May 26th, 2022

Monte Hilleman, SVP Sustainable Development
St. Paul Port Authority (SPPA)
400 Wabasha St N, Suite 240
St. Paul, MN 55102

The Heights (formerly Hillcrest) Redevelopment
Urban Design Work Group – Letter of Consensus Recommendations

Figure 1. Privately-owned public space (POPS) in The Heights

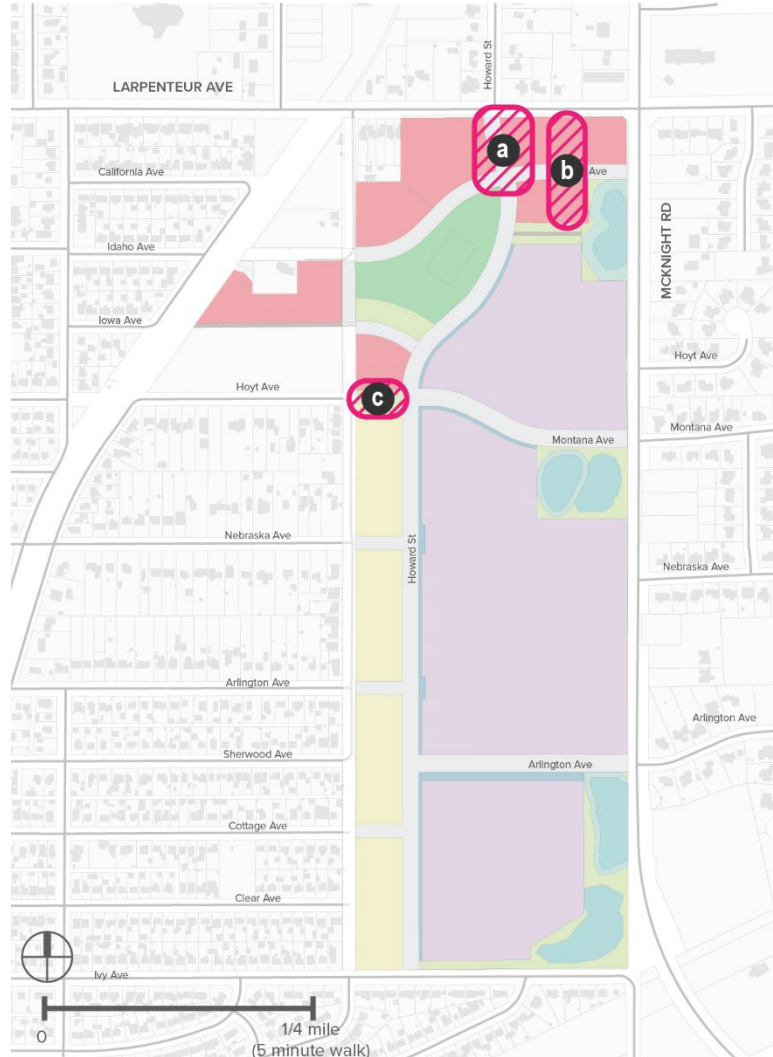
8. **Programming** – In addition to providing varied amenities for residents, employees, and visitors, privately-owned public space (POPS) should be provided in strategic locations

throughout The Heights (see Figure 1). These POPS should be owned, operated, and maintained by the developer/owner, provide 24-hour public access, and include a diverse range of programming. Potential locations have been identified as:

- a. Curved zones right along Howard between Larpenteur and Idaho.
- b. The north-south pedestrian alley on the northeastern-most block, connecting Larpenteur to the northernmost wetland.
- c. Hoyt Avenue pedestrian greenway connection.

Figure 2. Locations for 3rd story step-backs: pink – strongly preferred; orange – preferred

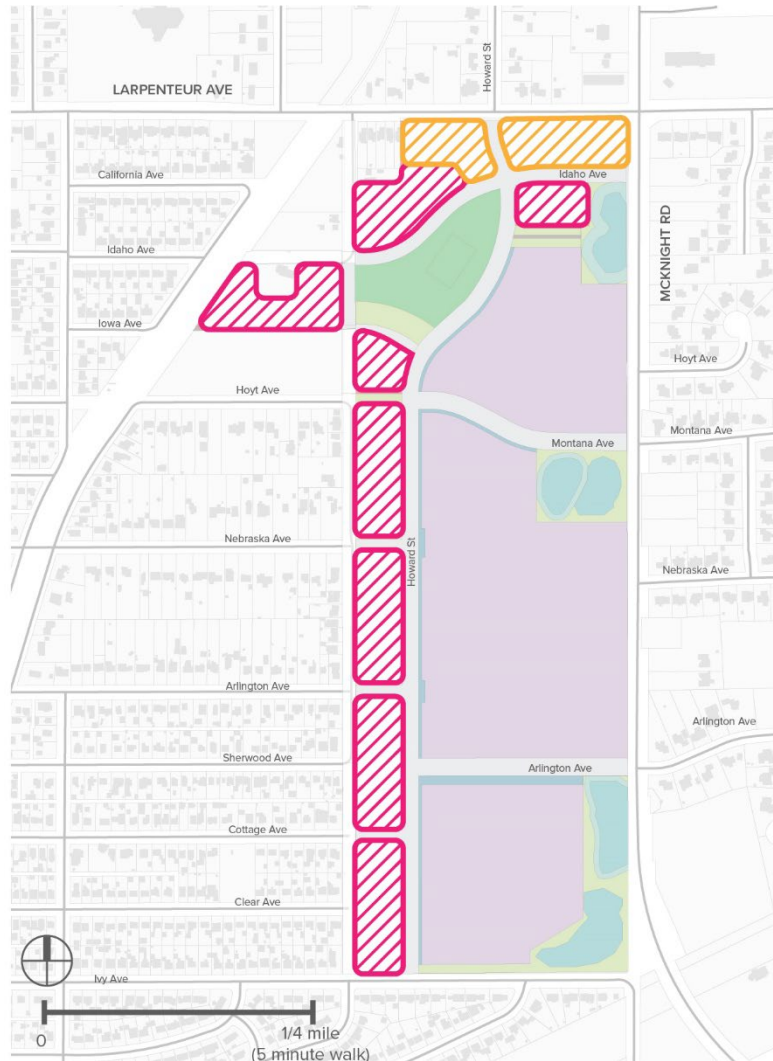
- In keeping with the neighborhood’s Modern ethos, buildings in The Heights should be contemporary in form, support solar paneling, and utilize a tightly edited palette of high-quality materials.
- Step-backs should be utilized in strategic locations (see Figure 2) to reduce the perceived scale of new development relative to the existing neighborhood and the scale of pedestrians.
 - Strongly preferred third-story step-back along interior ROW outside of neighborhood node, and Winthrop and Ivy.
 - Preferred third-story step back along interior roads within the neighborhood node.

Figure 5. Light Industrial building color palette (from hexadecimal color code)

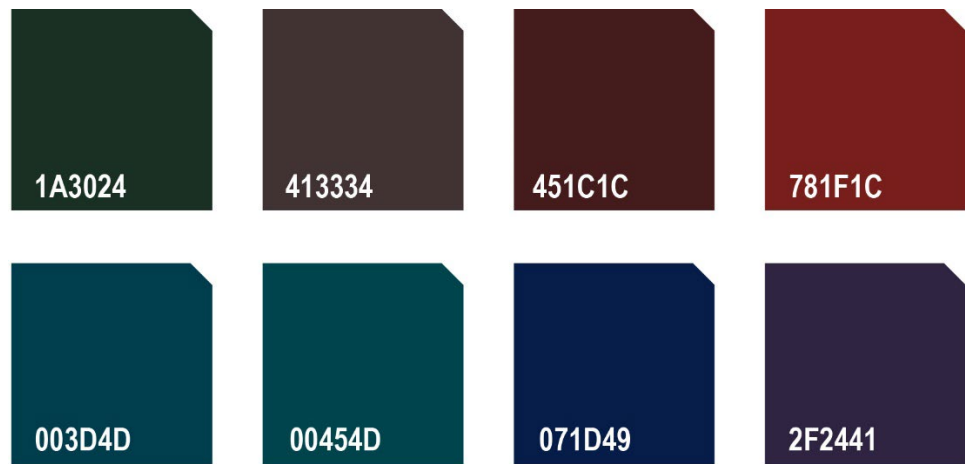
- We understand that the City of St. Paul has discussed this approach as fulfilling “alternative compliance” for current zoning requirements for the appearance of this type of building.
- We believe that the Arts & Employment District approach to light industrial development will provide community amenities and neighborhood beautification above and beyond those currently required by the City of St. Paul zoning code and we welcome its adoption at The Heights.
- The following requirements should be added to the Arts & Employment District guidelines:
 - Exterior building colors should be restricted to a cohesive “jewel-tone” color palette from a limited palette of specific, approved colors (see Figure 5).

- These colors should be rich and dark in tone and add subtle design interest to the neighborhood. By limiting the color palette, building owners may maintain a suitable background to showcase the mural art.
- No two adjacent properties, regardless of whether they are separated by a public right-of-way, may have the same exterior color.
- Building entries should have enhanced glazing levels (i.e. lots of windows).
- Building entries should conform to the standard tower/vestibule concept put forth by the Port Authority’s consultant team at Meeting 8 of this Work Group. We feel that plenty of visual interest and variety is being provided by the murals and vegetation around the building, and that consistency should be maintained in the design of the entries (see Figure 6).

Figure 7. Building orientation: pink – facing E/W streets; orange – facing N/S

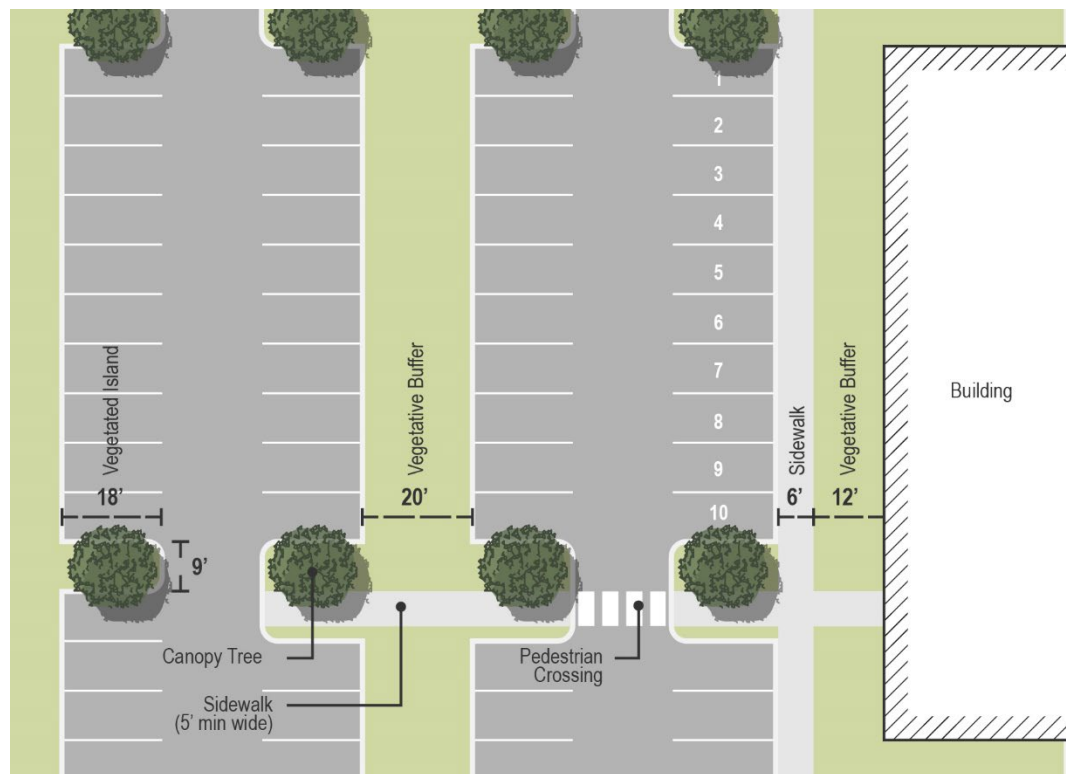
- In locations where four rows of parking run parallel to each other, the first parking/drive-aisle/parking zone should be separated from the second with a

parallel, 20'-wide vegetative buffer. The vegetative buffer should be used for green infrastructure stormwater treatment as much as is practical (see Figure 7).

- For every ten parking spots, a 9 x 18' vegetated island should be included in the parking lot layout. This island should be planted with a canopy tree (see Figure 7).
- Clearly marked pedestrian sidewalks and crossings should be provided perpendicular to the orientation of the drive aisles. These sidewalks/crossings should be a minimum 5'-wide and cannot be located within vegetated islands, but instead should be located adjacent to them.
- A minimum 6'-wide sidewalk should run parallel to the parking row nearest the building (see Figure 7).
- A minimum 12'-wide vegetative buffer should run parallel to the parking rows/sidewalk next to the building façade (see Figure 7).
